DOE Packaging Certification Program

**Safety Evaluation Report for
Certificate of Compliance No. 9341 Renewal and
Amendment for the Model BEA Research Reactor (BRR)
Package**

Docket No. 20-02-9341

Figure 1. Simplified Representation of Pu-238 Production Target Support

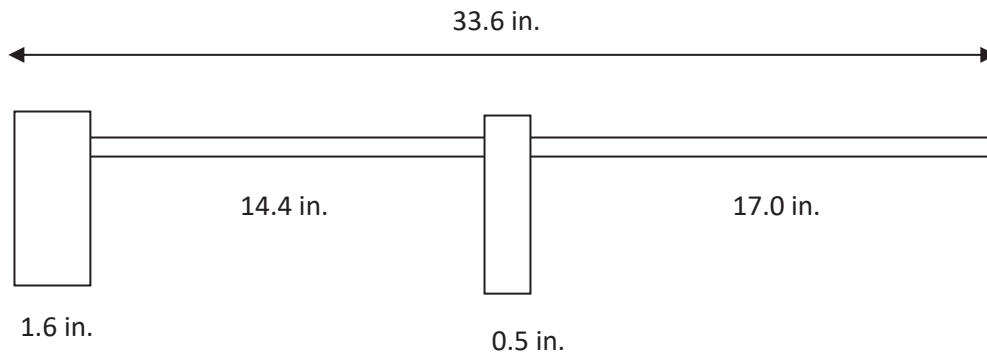
DOE PCP staff review determined (Q3-1) that the PFS Targets were supported in such a way that they were vulnerable to failure in an HAC side drop. Specifically, in a side drop the upper portion of the target has a large, cantilevered portion resulting in a large moment at the edge of the cantilever support. The applicant confirmed that failure of the target could not be easily discounted and submitted a revised thermal and shielding analyses in SARP Rev. 2 that assumed target failure and rearrangement of the target rods in the Square Fuel Basket.

Figure 1 below shows a simplified representation how a single target is supported, with the center rod and upper plate of the Target Rack omitted in the figure. The upper plate restricts longitudinal movement only and does not provide lateral support to the PFS

Targets. As can be seen from the figure, the cantilevered portion of the target exceeds the length of the simple supported portion of the target.

Given a cantilevered free length of “a” and a distributed constant weight “w” across the entire length of the target, the moment at the cantilever edge is:

$$M_{2max} = \frac{w \cdot g \cdot a^2}{2}$$

Assuming a 120 g side loading ($g = 120$, $w = 0.0299$ lb./in., $a = 17.25$ in), the moment at the cantilever edge M_{2max} is 533.827 in-lb.

The applicant concurred that this moment was potentially sufficient to completely fracture the fuel cladding by bending at the cantilever support. To address this issue, the applicant revised SARP Rev. 1, to assume target failure and rearrangement in both the thermal and shielding analyses. The target rearrangement shown in Figure 2 below assumes the targets form a rectangular slab at the lower portion of each of the six occupied Square Fuel Basket positions. Crucially, the length of the slab is still assumed to be the original 33.6-inch length of an undamaged target. In this configuration, the applicant assumes that the individual NpO_2/Al pellets remain locked in the target debris with the same axial distribution. The applicant bases this assertion on the hydrostatic compression of 30,000 psi during fabrication as well as experience with removal of fuel pellets from irradiated targets (SARP Reference Section 1.3.1.4, *Irradiation Testing of NpO_2-Al Cermet Pellet Targets in Support of Pu-238 Production at the High Flux Isotope Reactor*, ORNL/TM-2017/9).

Figure 2. Pu-238 Target Reconfiguration in Square Fuel Basket

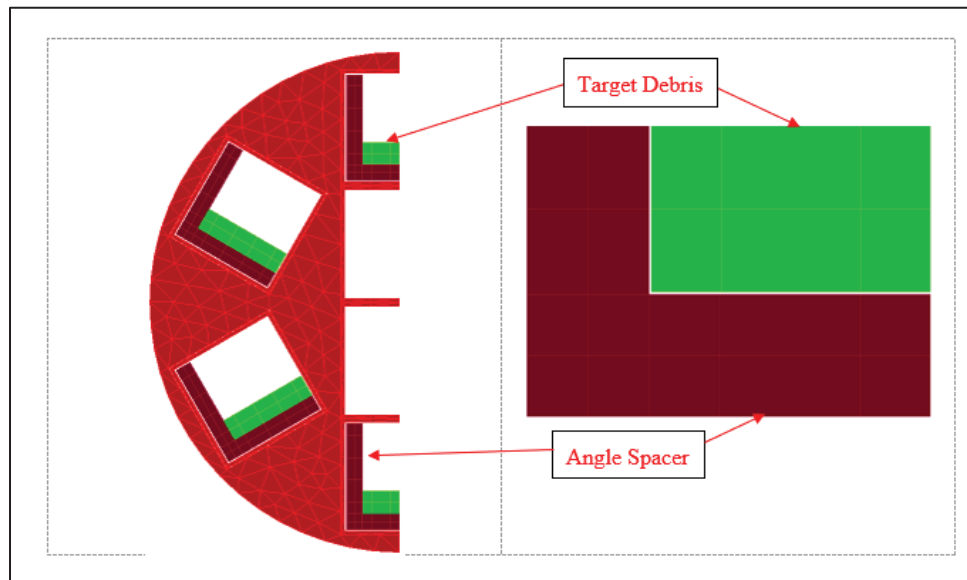
Although the applicant could not provide test data for the bending failure of PFS Targets, DOE PCP staff noted in the side drop scenario that the moment calculated above (M_{2max}) only applies until deflection of the target is stopped by the walls of the Square Fuel Basket cavity or support from another target. Staff investigated the deflection of a single PFS Target in a side drop scenario by applying an instantaneous distributed inertial load of 120 g using ABAQUS explicit finite element (FE) analysis. Staff assumed for the FE Model, that the PFS Target cladding is manufactured from 6061-T4 aluminum (ORNL/TM-2017/9) and filled with NpO_2/Al pellets along the entire target length.

Figure 3. Staff Estimate of Target Stress and Strain in 120g Side Drop

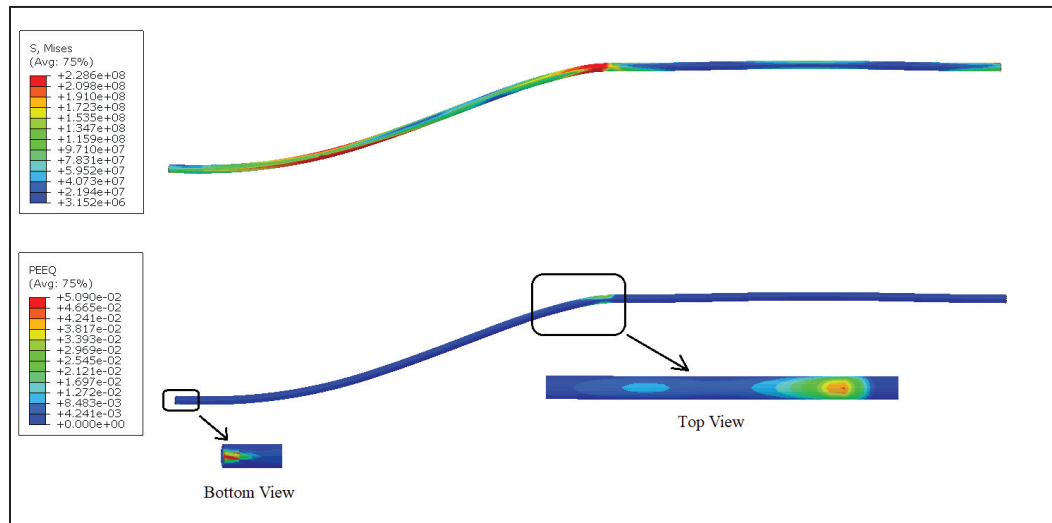
DOE PCP staff results of the side drop FE analysis, assuming deceleration of 120g at the time frame of maximum deflection, are shown in Figure 3, below. The FE embrittled model predicted a maximum stress in the cladding of 234 MPa. This value is above the assumed 221 MPa yield strength, but below the typical 6061-T4 ultimate tensile strength of 241 MPa where damage and crack initiation will occur. The stress at the PFS Target tip was lower. The maximum plastic equivalent strain in the target, of approximately 5%, was well below the failure plastic equivalent strain of 12%. This case bounded the ductile case.

While these results, which were obtained with unconfirmed material properties, do not prove that the PFS Targets will not fracture, they do provide reasonable assurance to the applicant's position that the NpO_2/Al pellets are unlikely to separate from the cladding and consolidate in a manner that would significantly affect the revised thermal and shielding analyses detailed in SARP Sections 3.7.4.3.3 and 5.7.4.5.

In SARP Section 3.7.4.3.3, the applicant postulated that a bending failure of the PFS Target could occur under NCT or HAC from the free-drop test with the package in a side-drop (horizontal) orientation. DOE PCP staff did not analyze PFS Target response under the NCT side drop orientation, because the stresses and strains to the targets under NCT are unlikely to cause the release of fuel pellets, since it occurs at much lower stresses and strains than under HAC.
